***A.T. Still University  
Expansion***

**Planning & Zoning Submittal  
City of Mesa  
PS15-089**

**November 30, 2015  
Revised: June 24, 2016**

**RECKER ROAD SECTION**  
 SCALE: 1/16"=1'-0" LOOKING NORTH

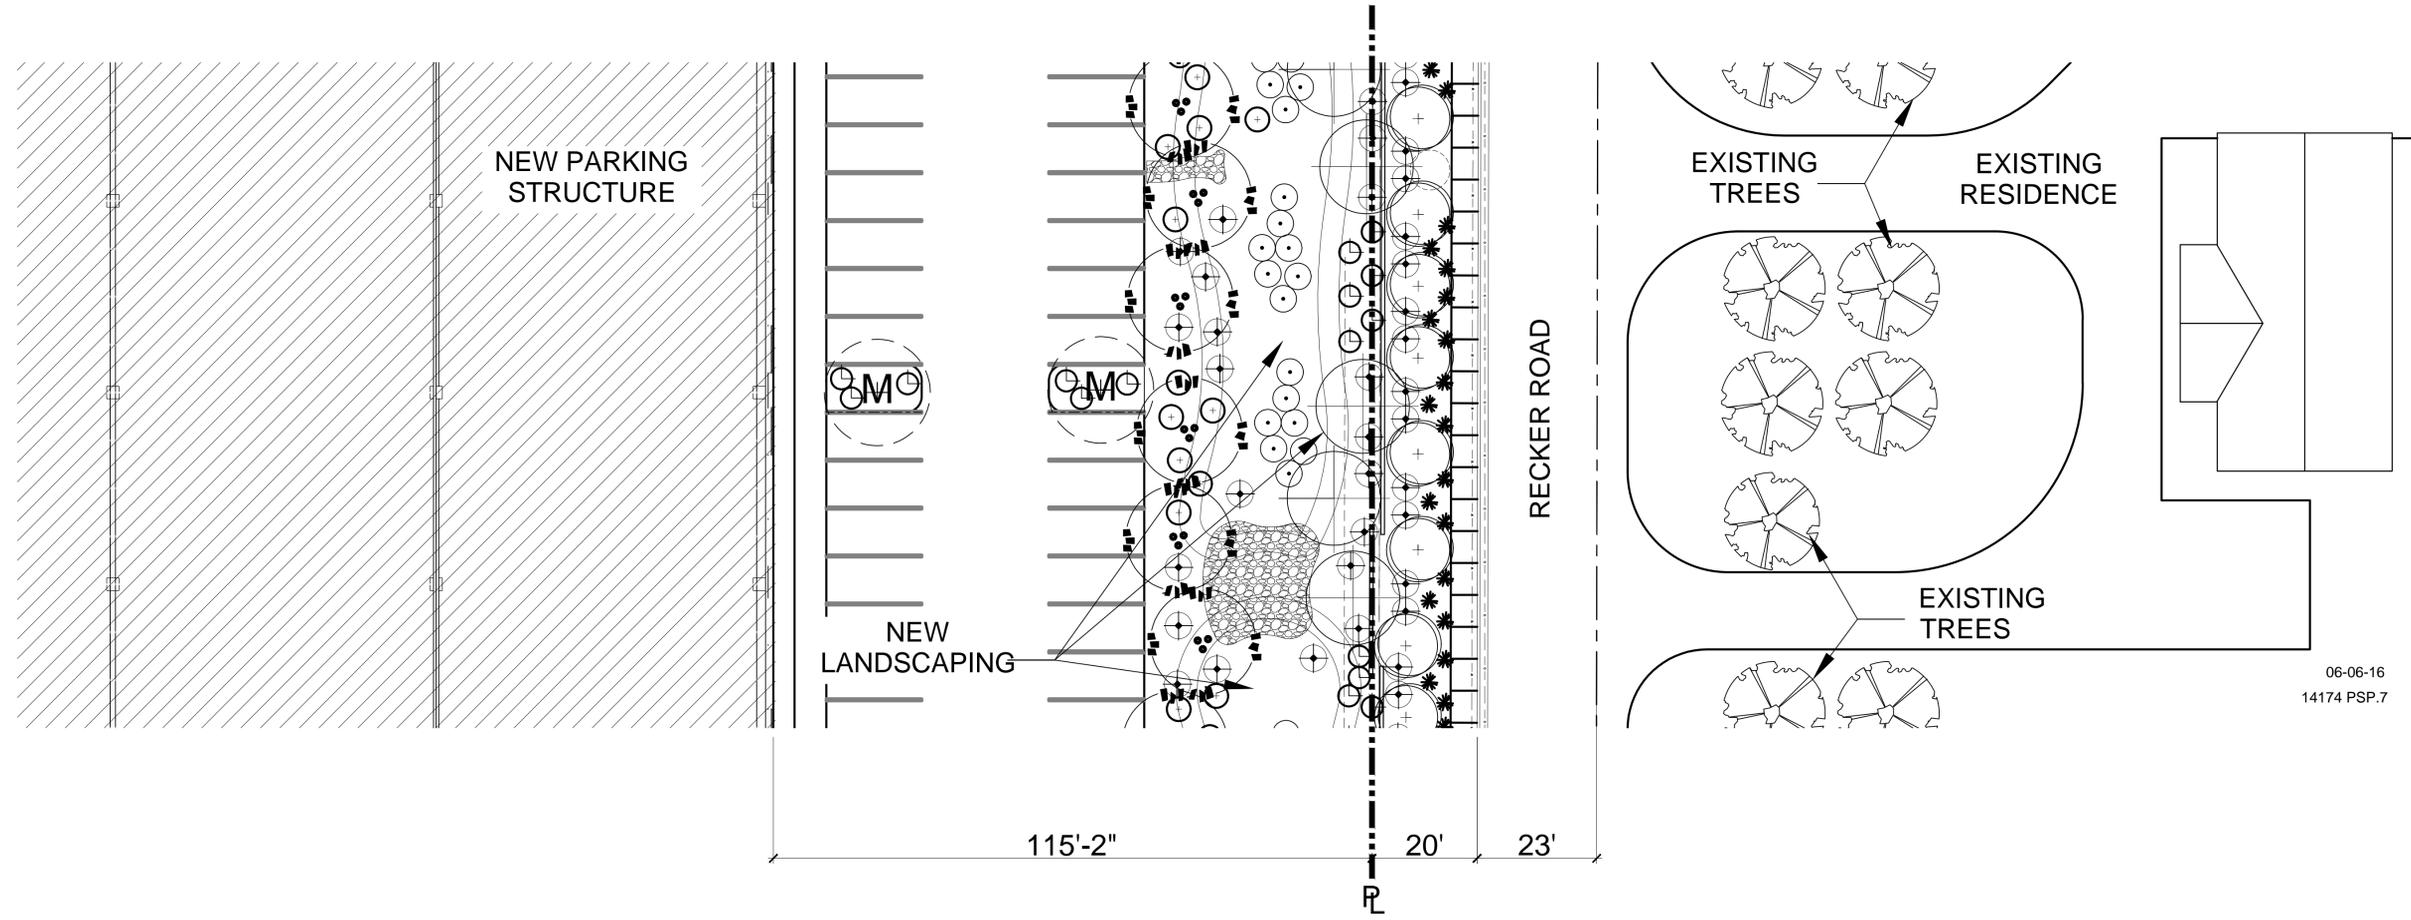
- The desire to have the open areas in the garage on the east side closed so as to more fully conceal the sound and light pollution that the garage will generate from the Recker Community. Additionally, and maybe more importantly, this would add to the security concerns of the community by restricting the vantage point of those on the upper levels of the garage.

- The drawings still show the existing overhead power lines along Recker Rd. The development team again stated verbally that this was a mere oversight in drafting and that the power lines would be buried. The drawings further show low growth trees along Recker Rd. The trees along Recker need to be high growth trees to maximize the visual blockade and the power lines need to be buried. The development team took no issue with this, and agreed to have it documented in some way.

- The development team did not take issue with this request and appeared to be fully open and agreeable to making this correction. However they did mention that instruction was given by City of Mesa officials and PD that these are to remain open for security reasons (PD to see in). They did say that this was more related to the ground level. The Recker community is not concerned as much with the ground level and would be content with concealment of the those levels above ground level.
